Safety Defect and Noncompliance Report Guide for Vehicles

PART 573 Defect and Noncompliance Report⁽¹⁾

Charlot Eagle West, Inc.
8100 West Buckeye Road
Phoenix, Arizona 85043

PROCEDURE FOR CONVERTING A VENTED FURNACE DOOR TO NON-VENTED DOOR

FURNACE DOOR

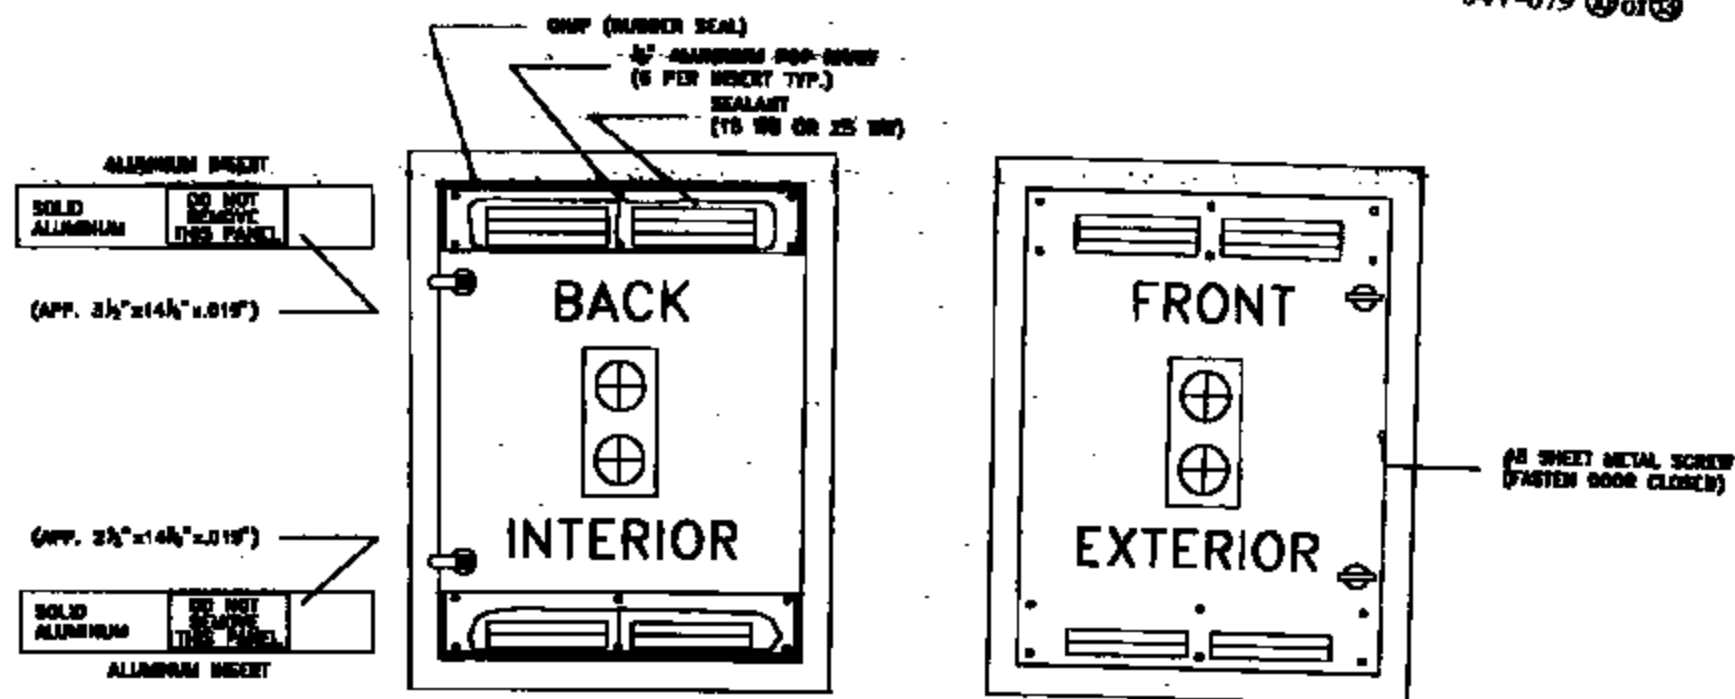
SCOPE: To Block Off Air Passage Through Louvers In Exterior Furnace Doors (Top And Bottom Louvers)

- STEP:**
1. Remove exterior furnace vent in door.
 2. Open door.
 3. Remove rubber gimp inside door (use hook device to get gimp started - see attached print).

4. Check and measure to see that flat aluminum fits properly inside to cover louvers and it also must be under gimp when re-installed (larger opening is at the top of the door).

5. With flat aluminum not installed in door, apply bead of sealant around louvers and through center of louvers on the inside of the door.
 6. Insert flat aluminum over louvers and re-install gimp on edges.

7. Install six (6) pop-rivets per each aluminum insert, as shown in the drawing.
 8. Apply a bead of sealant to the edge of the aluminum insert that is not under gimp.

9. Apply "DO NOT REMOVE" labels to both aluminum inserts.
 10. Close the door and re-install the exterior vent.
 11. On the latch side of the door (in center of edge frame) drill a 1/8" pilot hole and install #8 sheet metal screw (this will prevent accidental opening of the door).

Aluminum cover plates will be installed with fire burner sealant to prevent air leaks. Plus pop rivets to prevent removal.
